THE ROVER COMPANY LIMITED
S E R V I C E D E P A R T M E N T

Rover Service News Letter No. 55

May, 1955

Fig. 1. Piston identification.

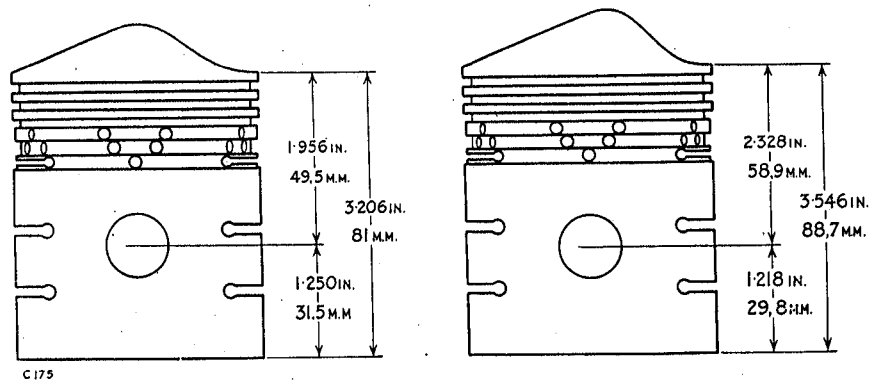
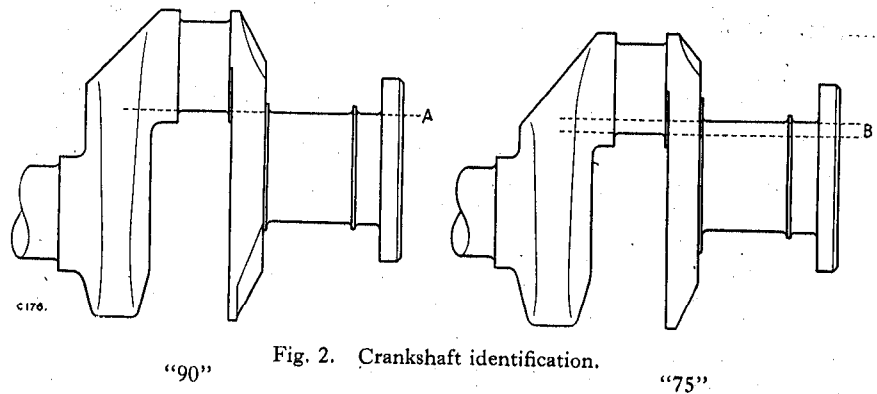
- Item 117 SUBJECT: PISTONS AND CRANKSHAFT.**
MODELS: 1954-55 "90", 1955 "75".
REMARKS: As the cylinder bore size of the 1954-55 "90" and the 1955 "75" is exactly the same, with little difference in the overall height of the piston, and with the basic dimensions of the crankshaft identical; it follows that stock can easily be confused if only a superficial examination is given when binning, supplying or fitting these parts. Great care must be taken to ensure that the correct type of piston and crankshaft, for the model concerned, is supplied and fitted when engines in the above range are being overhauled.
- It is possible to fit the wrong pistons or crankshafts in either model and this could of course have disastrous results. The sketches below clearly show the means of identification of the two types of piston and crankshaft.

In addition the pistons can be identified by the casting number on the inside of the piston skirt as follows:—

“75” Casting No. M1577-2, “90” Casting No. 240633.

Fig. 3. Order of tightening cylinder head bolts. (“75” and “90” models with steel cylinder head gasket)

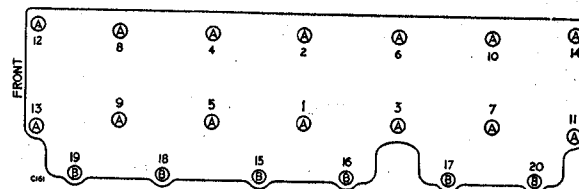
MODIFICATION: Corgasyl corrugated steel cylinder head gasket replaces copper and asbestos.

REMARKS: The “Corgasyl” steel gasket should not be fitted to models prior to those listed above, as a design modification to the cylinder head has also taken place and there is a danger of the steel gasket “blowing”, due to the possibility that one of the corrugations in the gasket may overlap the holes for the inlet push rods.

After tightening down the cylinder head bolts in the order and to the specified torque as shown at Fig. 3 a re-check of the torque figures must be made.

This operation is necessary to counteract reduction in torque of adjacent bolts during initial tightening owing to flattening out of the corrugations.

Bolts A to be tightened to 50 lbs./ft. (7 mKg.)
 Bolts B to be tightened to 30 lbs./ft. (4 mKg.)

Fig. 4. Land-Rover chassis frame showing body angles—"A".

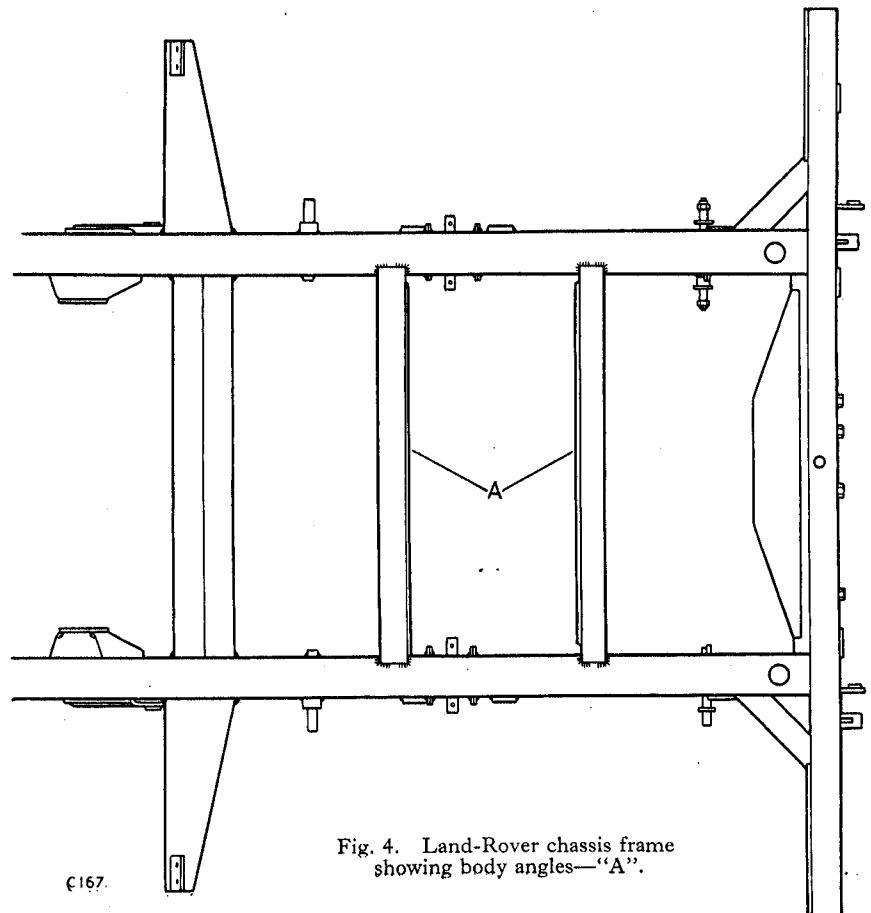
Item 124 SUBJECT: **CHASSIS FRAME, COMPOSITE TYPE.**
 MODELS: 1950 Land-Rover from vehicles numbered 06113530 (Basic), 06200410 (Station Wagon) and 06300031 (Welder) onwards.
 1951-53 Land-Rover
 REMARKS: Future supplies of chassis frame Part No. 236805 will be complete with the body support angles suitable for the 1952-53 Land-Rover. When using these chassis frames on 1950-51 models, in the range detailed above, it will be necessary to remove those body support angles marked "A" in the sketch below.

Fig. 5. Basic attachment bracket and towing jaw supplied with each Land-Rover, showing alternative positions for the towing jaw. Part numbers as detailed above.

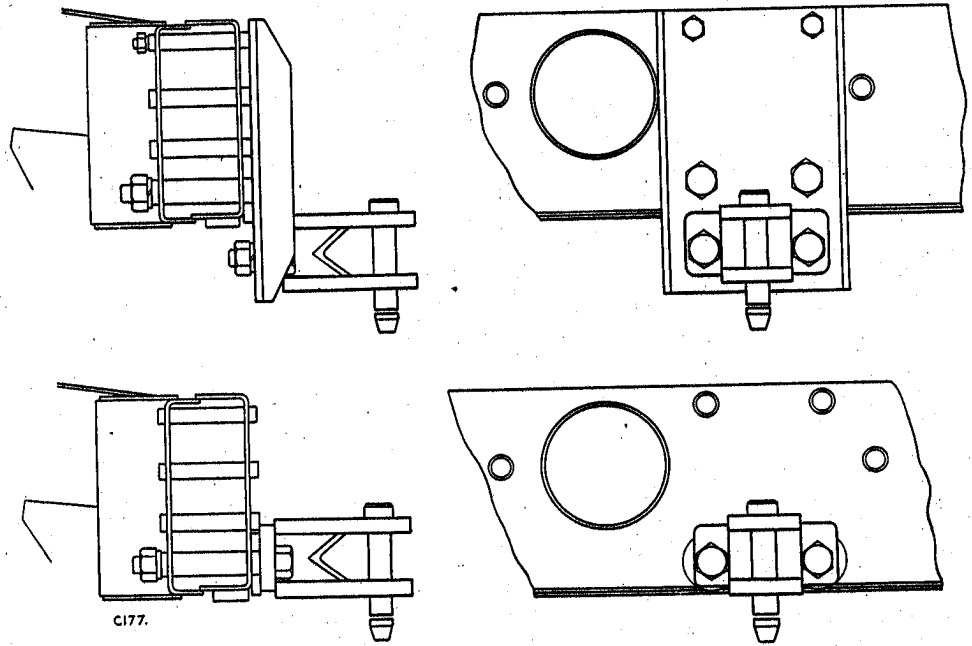
MODIFICATION: Introduction of revised towing attachment as detailed below:—

REMARKS: The towing attachments supplied with the basic Land-Rover from the vehicle numbers as detailed above are:

Bracket for towing jaw, part number 264522, and towing jaw, part number 233828, as shown in Fig. 5 below.

Fig. 7. Land-Rover 86 Station Wagon towing jaw, supplied as basic equipment with each Station Wagon.

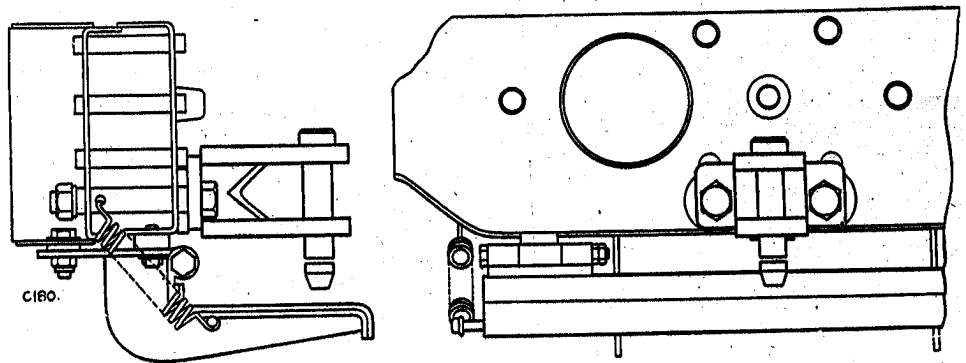
Service part number 233828.

Fig. 8. Rear tow plate.

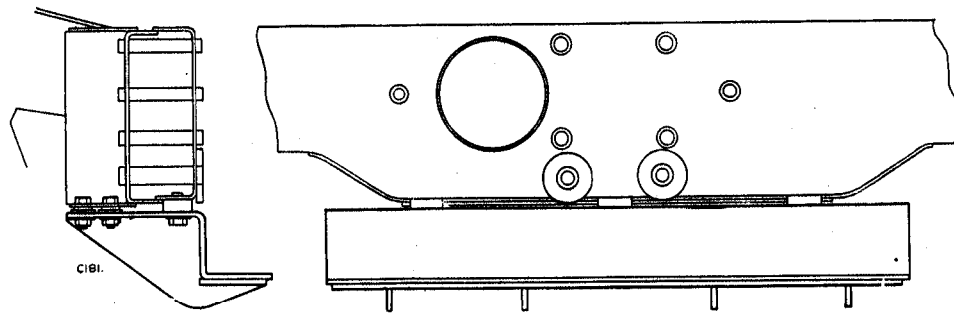
This item, which is now an Extra, was formerly supplied as part of the basic vehicle.
Extra designation E.109. Service part number 265088.

Fig. 9. Rear tow plate must be used, in conjunction with the tow plate illustrated at Fig. 8, when the rear power take off drive is fitted and the basic towing jaw is also required.
Service part number 231213.

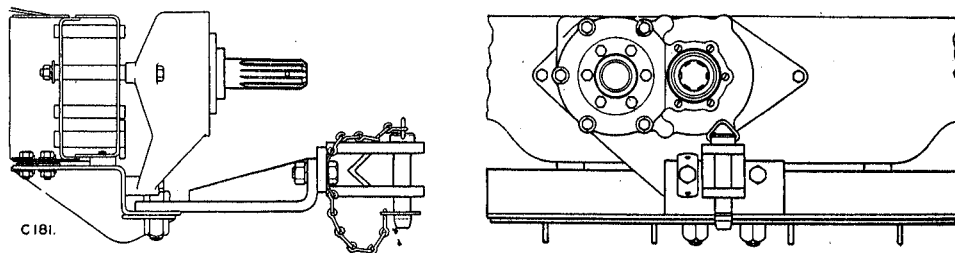
NOTE.—Future supplies of the rear power take-off will include the rear tow plate, part number 265088.
